January 28, 2019

Subject: Comment – Tentative Order R9-2019-0003

CARLSBAD DESALINATION PLANT

REVISED ENTRAINMENT ANALYSIS FOR BRINE DISCHARGE OPTIONS

Figure 1: Relationship between Impingement and MGD for 50 "ordinary" events.

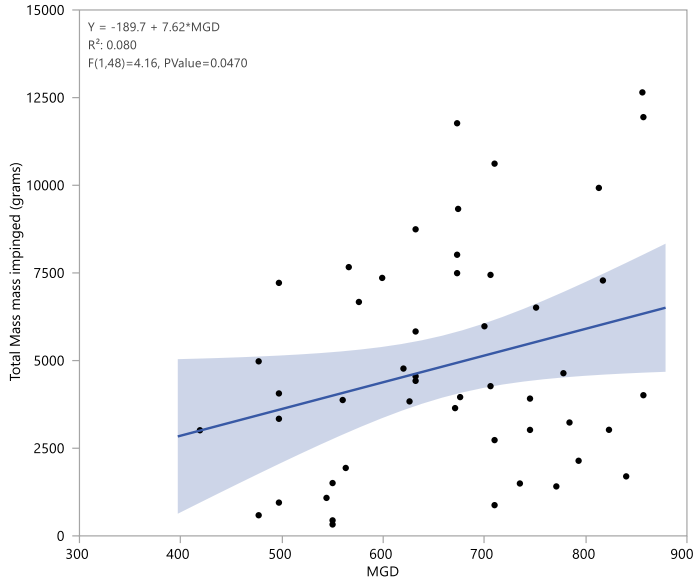
The relationship depicted in figure 1, as expected, shows an increase in impingement as MGD increases. However the relationship is much weaker than expected. This is due to the high level of simple temporal variability in impingement unrelated to flow (e.g. pulses of individuals near the intake structure). Adding the two extraordinarily high impingement events corrupts the relationship entirely (see figure 2 below).

Figure 2: Relationship between Impingement and MGD for 50 "ordinary" (red) and "extraordinary" (blue).

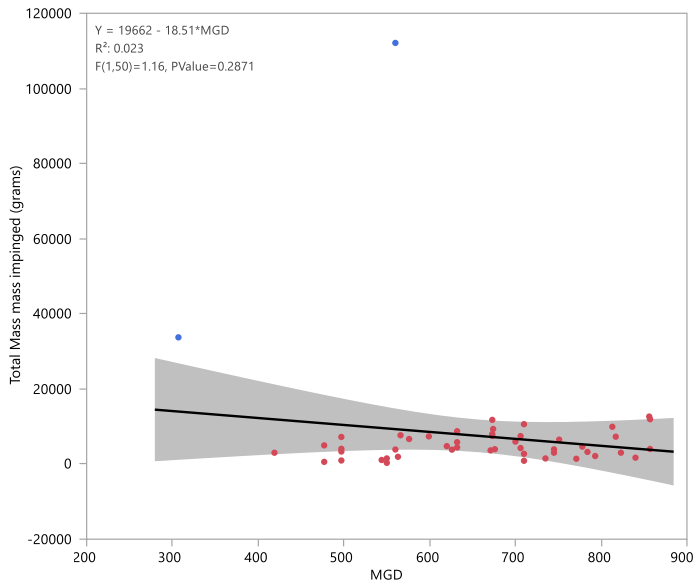
Including all 52 events causes the relationship to shift from positive (figure 1) to negative (figure 2). Note that the relationship is significant in figure 1 ($p = 0.047$) but not in figure 2 ($p=0.2871$). It is clear that the inclusion of all data corrupts the relationship between MGD and impingement. Nordby recognized this and derived an estimate of impingement related to CDP MGD that was based on a hybrid approach. The 50 ordinary events were calibrated by the MGD ratio noted above and the 2 extraordinary events were not. This led to an estimated daily impingement rate of 4.7 kg per day (=10.36 lbs per day). For comparison, calibrating all the data and using the relationship shown in figure 2, the estimate for 304 MGD would have been 14.03 kg per day (at the 50% confidence limit).
